South Texas Project Electric Generating Station P.O. Box 289 Wadsworth, Texas 77483

November 22, 2010  
U7-C-STP-NRC-100241

South Texas Project  
Units 3 and 4  
Docket Nos. 52-012 and 52-013  
Response to Request for Additional Information

Figure 2.4S.4-13a Breach Width Development for Different n-values

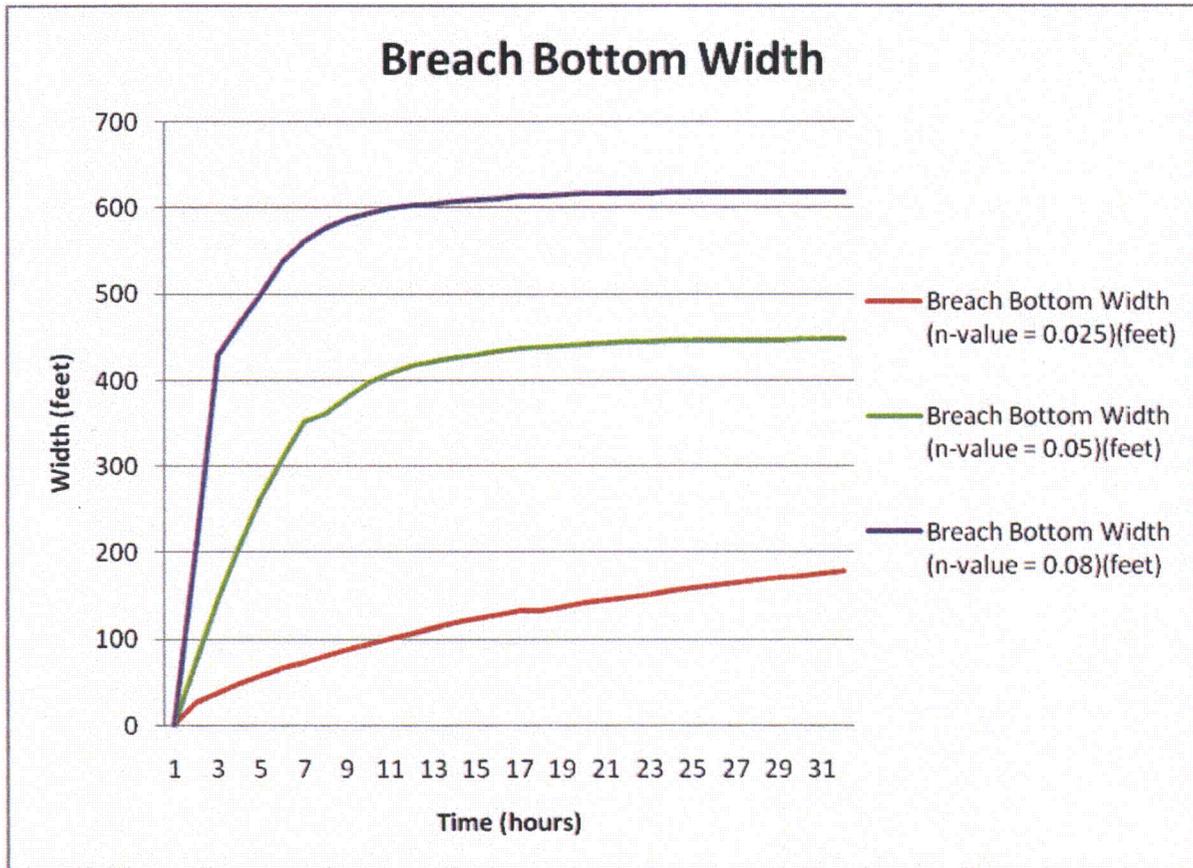
The BREACH algorithms are such that the lowest n-value considered, 0.025, produced a lower peak discharge than the highest n-value considered, 0.05. Therefore, consideration was given to a higher n-value of 0.08 that was still considered within the range of feasibility. Table 2.4S.4-6b presents the predicted peak discharge, breach width at time of peak discharge, time to peak discharge and reservoir level at time of peak discharge for each of the three n-values modeled. Figure 2.4S.4-13(a) presents the breach width development over time for all three n-values tested. The results of the sensitivity analysis indicate that higher roughness coefficients produce higher peak discharge values, which is counterintuitive. One explanation for this may be attributed to the model predicting a sudden collapse of the pipe section of the dam sooner with the lower n-values, thus lowering the peak discharge at a critical time. It is noted that the peak discharge and breach opening rate is based on several modeling algorithms that are balancing discharge forces, sediment transport rates and structural features with predicted storage depth and tailwater depth. An n-value of 0.05 is used in the FLDWAV analysis.

The following figure will be added to the FSAR:

Figure 2.4S.4-13b Breach Bottom Width Development from BREACH analysis

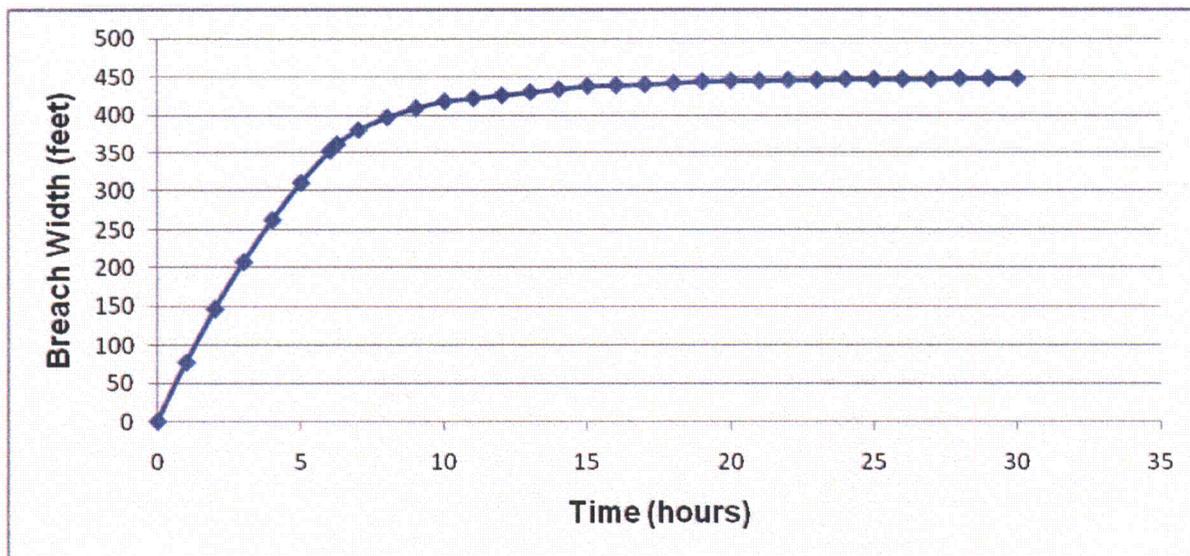
The BREACH model results showing breach width development with respect to time of breach formation are presented in Figure 2.4S.4-13(b). The breach width increases initially at a fairly constant rate for the first five hours, after which the rate of breach expansion decreases. The peak discharge of approximately 83,200 occurs when the breach bottom width is 361 feet. The reservoir water level continues to drop as water flows out of the reservoir through the breach and the downstream channel erodes as it carries the large outflow from the breach. It is noted that the rate of erosion would decrease substantially after the first five hours of the breach process. However, considering the large volume of water remaining in the MCR, the breach continues to expand with diminishing outflow and a decreasing breach width erosion rate. The final breach width reached after 30 hours is 448 feet.

The following figure will be added to the FSAR:

**Figure 2.4S.4-13c Comparison of BREACH and FLDWAV Outflow Hydrographs**

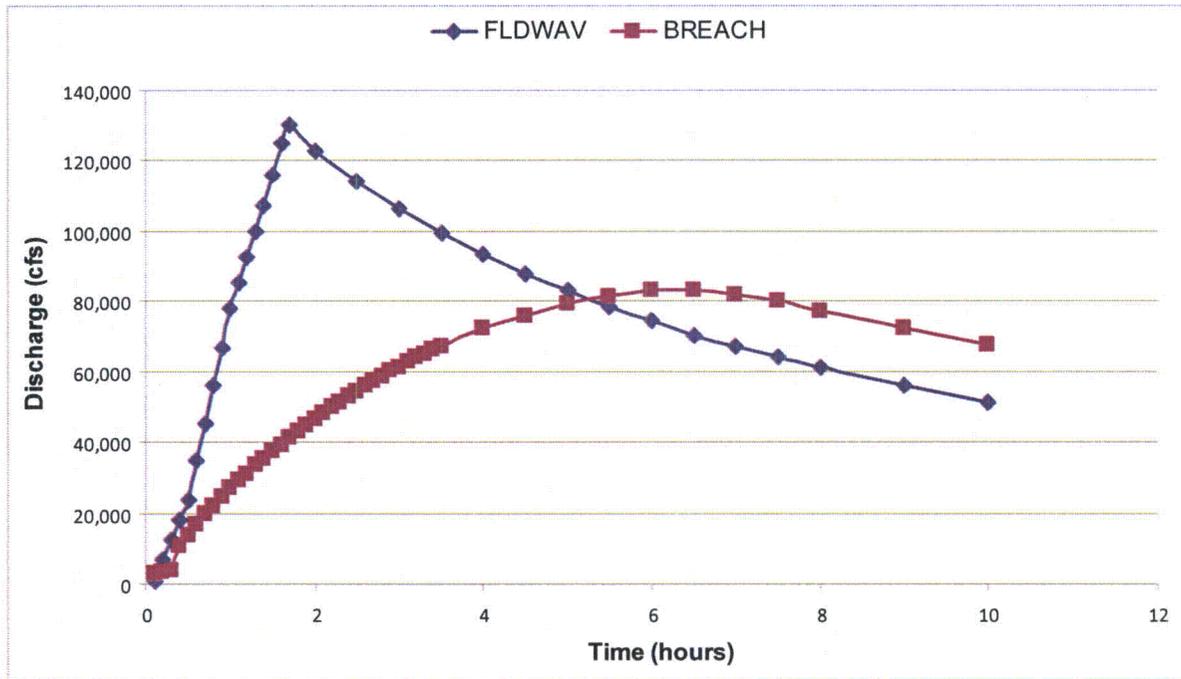
Table 2.4S.4-6c and Figure 2.4S.4-13(c) provide a comparison of the results from BREACH and FLDWAV. The breach width and time to peak used as input to the FLDWAV program were conservatively estimated based on case studies of historical dam failures presented in Reference 2.4S.4-12d. FLDWAV assumed a linear increase

The following figure will be added to the FSAR:

**Figure 2.4S.4-21j Breach Outflow and Flood Elevation to Determine Duration of Inundation at Safety-Related SSCs**

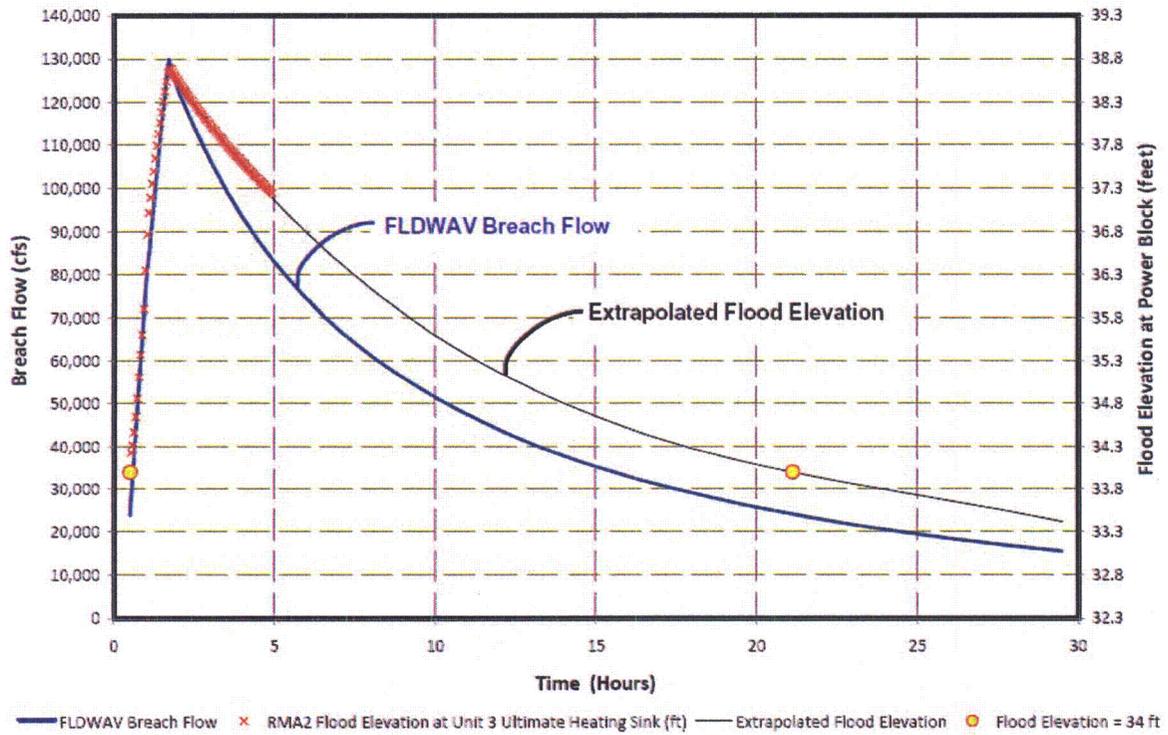
- (8) The duration of inundation at the power block is considered to be the duration during which the flood elevations are greater than the grade elevation of 34 feet. Subsection 2.4S.4.2.2.4.5 and Figure 2.4S.4-21(j) are added to address the duration of inundation. See FSAR markup.

The following figure will be added to the FSAR:

Figure 2.4S.4-21f1 Sediment Accumulation (in feet) from East Breach Scenario

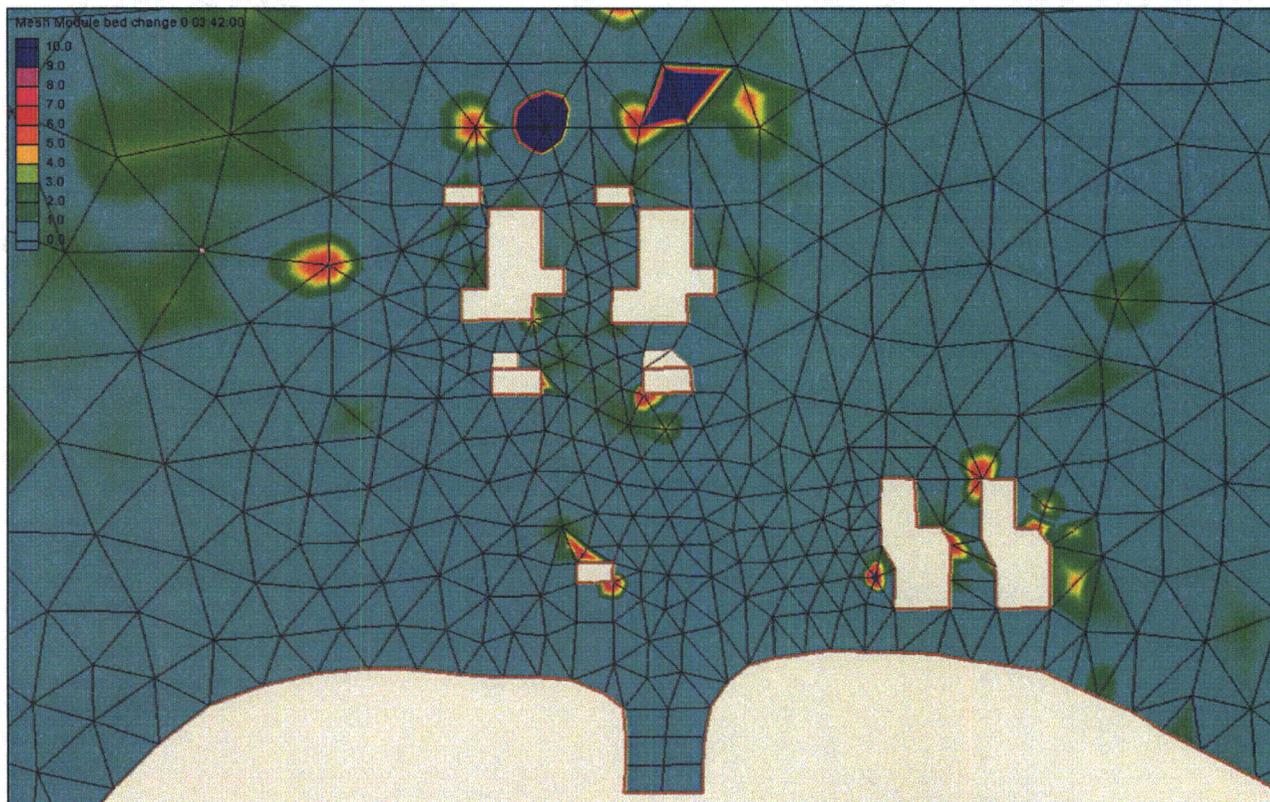
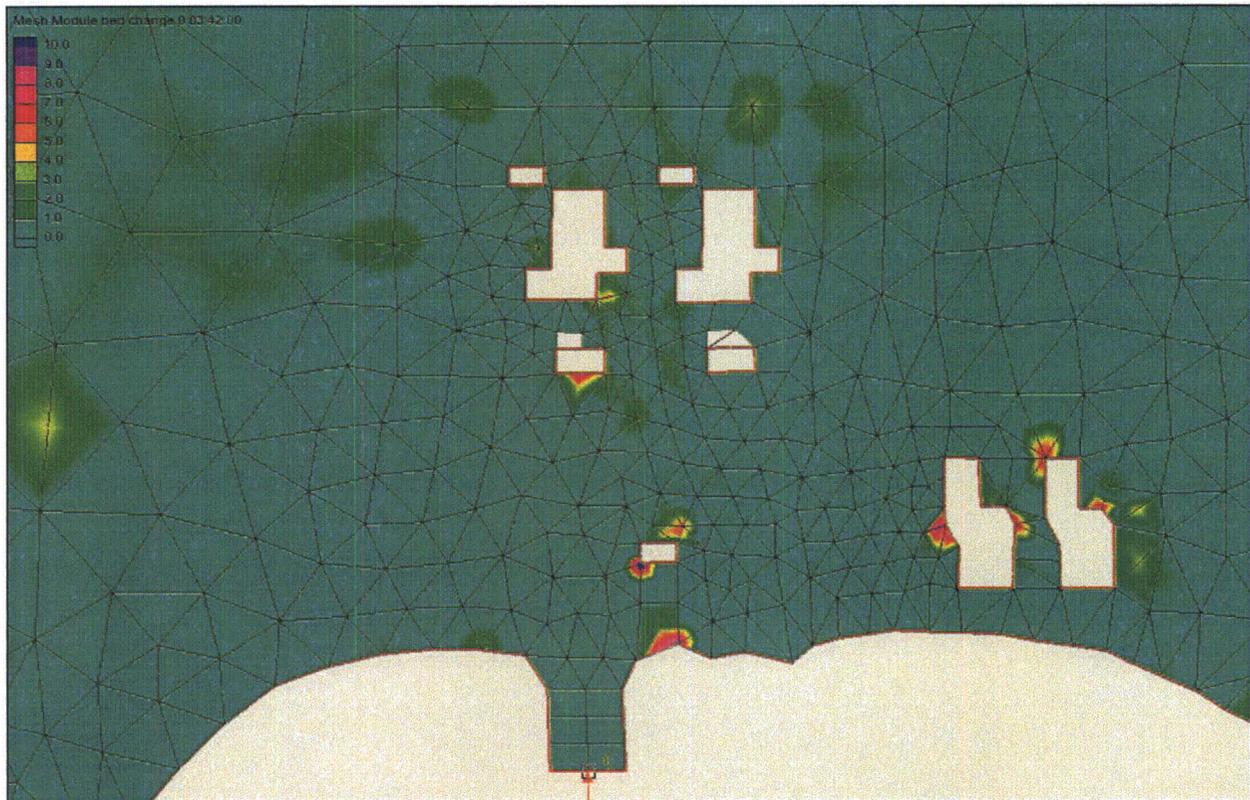
- (6) Subsection 2.4S.4.2.2.4.2 is updated to include a description of sediment mass balance for the SED2D simulations. Refer to FSAR markup.
- (7) Figures 2.4S.4-21f1 and 2.4S.4-21f2 provide sediment deposition height maps. As discussed in Subsection 2.4S.4.2.2.4.2 the anticipated erosion/scouring within the powerblock area is not significant.

SED2D sediment modeling indicated some deposition on the outer edge of the model domain and relatively little deposition within the STP site. Figures 2.4S-4-21(f1) and 2.4S-4-21(f2) show the sediment accumulation pattern with accumulation at points where current velocities are relatively low for the east and west breaches, respectively. Table 2.4S-4-7b shows the amount of sediment accumulation at locations defined in Figures 2.4S-4-21(f3) and 2.4S-4-21(f4). These sediment deposition locations only involve a single 2D grid node, i.e. the node with sediment accumulation depth is surrounded by nodes with no sediment accumulation at all. This single-node result indicates isolated settling location due to very localized small velocity at the node. These results are consistent with the sediment concentration results in that the majority of the clay and sand loads would be suspended in the flood flow and washed downstream, beyond the STP site. SED2D modeling provides point elevation results that are not easy to integrate into a volume over a large area, but the small accumulation within the study area (Figures 2.4S-4-21f1 and f2) and the large accumulations noted in the sump outside of FM 521 indicated that the great majority of the sediment eroded settled in the model sump outside of FM 521. The localized single-node sediment accumulation predicted by SED2D also makes it impractical to apply the underlying 2D element area for sediment accumulation volume calculations because it will greatly over-estimate the amount of accumulated sediment volume if an artificial "pyramid" were assumed to be the sediment accumulation volume. While the user's manual of SED2D does not provide specific information about sediment mass balance in a model simulation, it states that the derivation of the SED2D model formulation is based on the basic convection - diffusion equation (Reference 2.4S-4-12j). This basic convection - diffusion equation is a mass balance equation based on the conservation of mass (Reference 2.4S-4-12k). Therefore, mass balance is embedded in the fundamental equations of SED2D and sediment mass balance is maintained by the program during the simulation.

The following figure will be added to the FSAR:

Figure 2.4S.4-21f5 Differences in Maximum Velocity (in ft/s) with and without Full Sediment Accumulation for East Breach Scenario

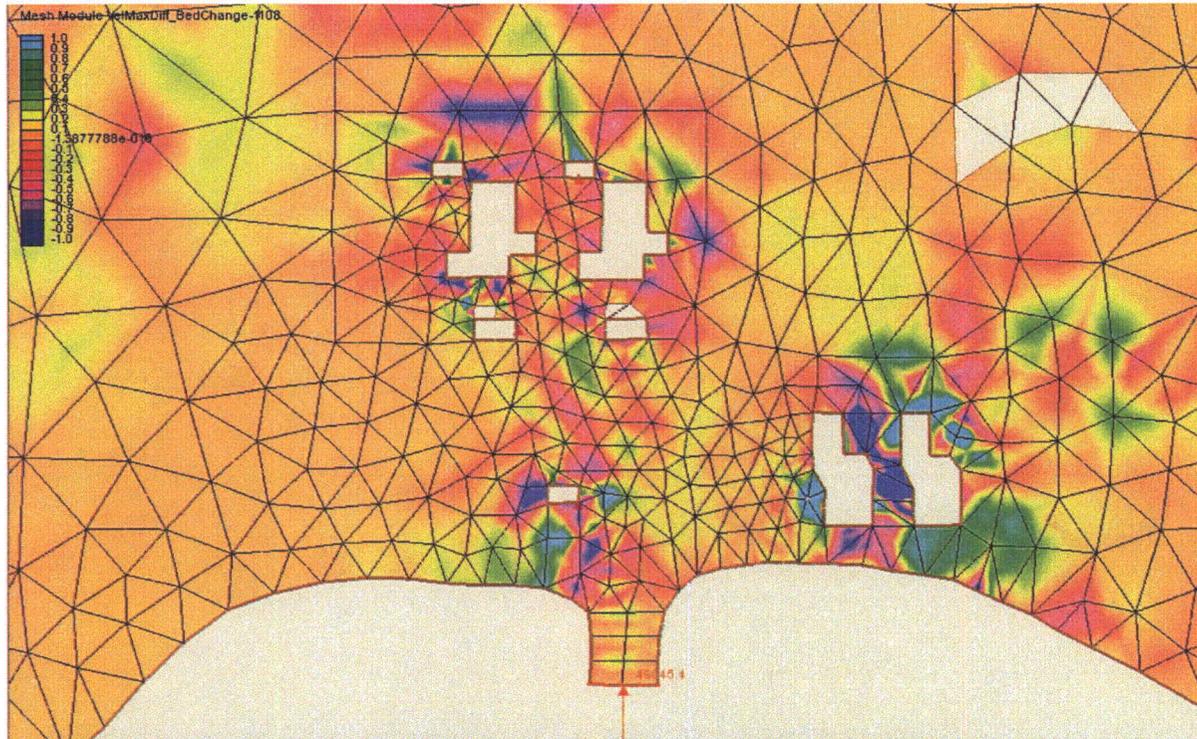
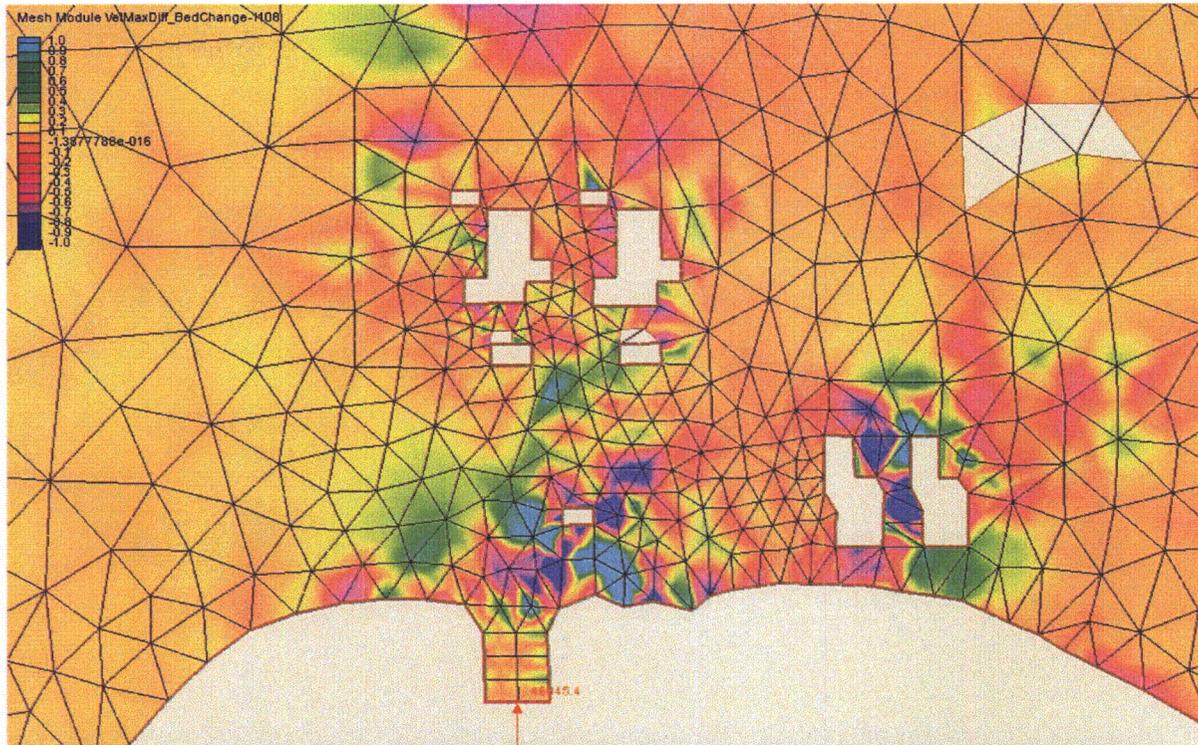
To test if selecting a large DEPLIMIT parameter was a potential issue, a sensitivity analysis was performed using the ultimate sediment accumulations within the STP site to create a revised RMA2 grid. The results of these sensitivity simulations for both the east and west breach scenarios are shown on Figures 2.4S.4-21(f5) and 2.4S.4-21(f6). The maximum velocity differences (up to 1 ft/s) occurred near the sediment deposition locations, which are a few local areas of low velocity. These figures show that velocity differences are very small over the rest of the power block area. No significant difference in the maximum current velocities between the two elevation grids, except at localized grid points, indicates that the sediment accumulation effect is not significant in this very short term simulation. From this it was concluded that the selected large DEPLIMIT parameter set to avoid model terminations was appropriate to the particular simulations, and it does not impact the simulated water surface elevation or sediment deposition in the vicinity of safety-related SSCs. The areas around the SSCs are high velocity areas where little or no sediment accumulation was predicted by the model.

The following figure will be added to the FSAR:

Figure 4. Storm Surge Height (ft above MSL) vs. Distance from Site

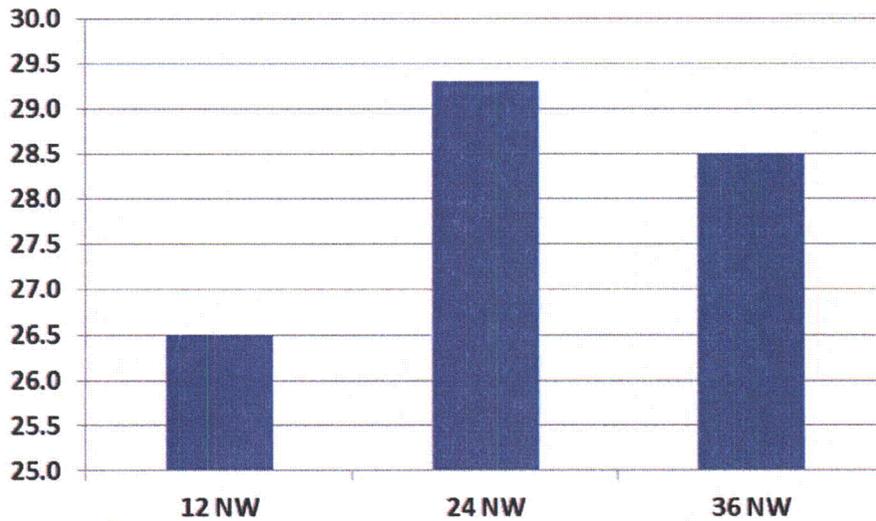
Figure 4 shows the maximum storm surge at the site as a function of the shortest distance of the storm track from the site. For these three scenarios, the track direction remained constant (northwest path). As indicated in Figure 4, the greatest storm surge occurs when the shortest distance of the storm track from the site is equal to the radius to maximum winds.

Figure 5. Storm Surge Height (ft above MSL) vs. Direction

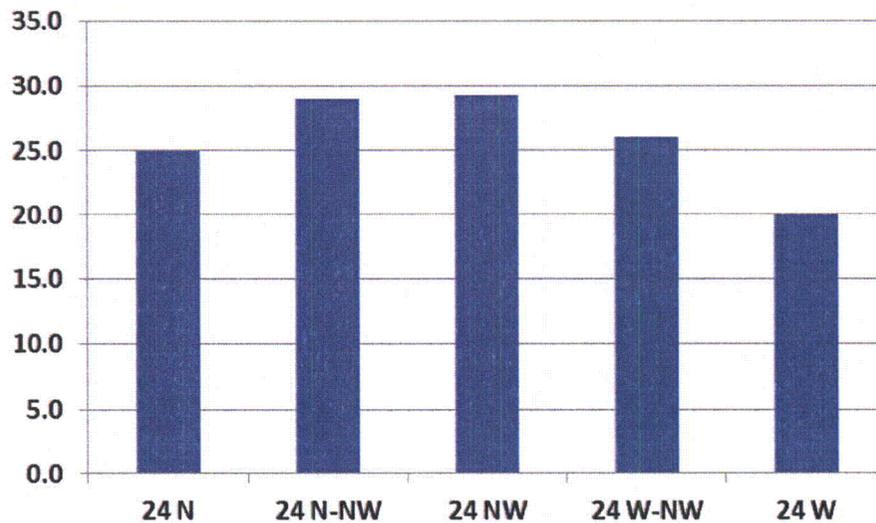
Figure 5 shows the maximum storm surge at the site as a function of the track direction relative to the site. For these five scenarios, the shortest distance of the storm track from the site remained constant (24 miles). As indicated in Figure 5, the greatest storm surge occurs when the track is generally heading in a northwesterly direction.

Figure 10 Cross Sections of the STP MCR Embankment and a Typical Texas City Levee

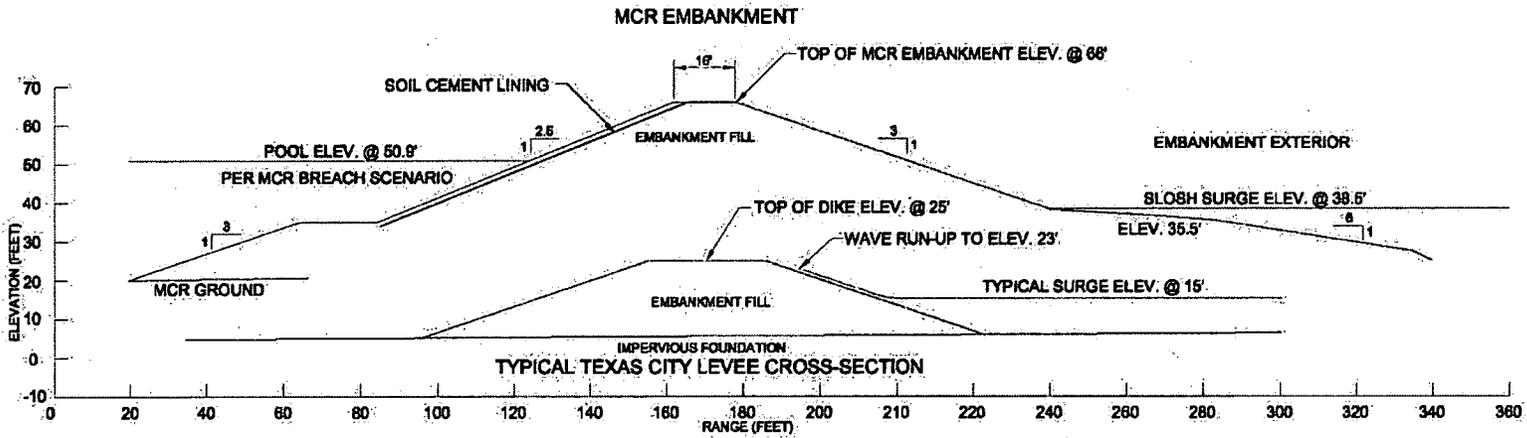
A typical cross section is shown in Figure 10. Also shown on the figure is a typical section of flood protection levee for Texas City. The Texas City levee has provided protection from hurricane surge over its life, and although that levee sustained damage during Hurricane Ike, the levee did fulfill its intended purpose of withstanding a substantial surge and wave attack over a period of many hours without a breach occurring anywhere along the 17 miles of the protective works (Reference 5). The MCR embankment is similar to, but much larger than, the hurricane surge protection levees that have, for the most part, successfully withstood major hurricane events along the US Gulf coast.

For perspective, Figure 10 also shows the typical hurricane surge level experienced by the Texas City levee and the peak surge level predicted by the 2010 version of SLOSH. There is no possibility that the STP PMSS could breach the MCR embankment. In contrast, the infamous levee failure in New Orleans during hurricane Katrina occurred due to the breach of a piling wall. This wall was constructed in dredged materials and sustained an impact force from a surge wave of significant height generated over a very short time period. The situation of New Orleans is vastly different from the MCR embankment because of the substantial size of the MCR embankment relative to that of a piling wall; the MCR foundation consists of competent clay materials relative to the failed levee location in New Orleans being founded on dredged material; and the landward side of the New Orleans levees are well below sea level.
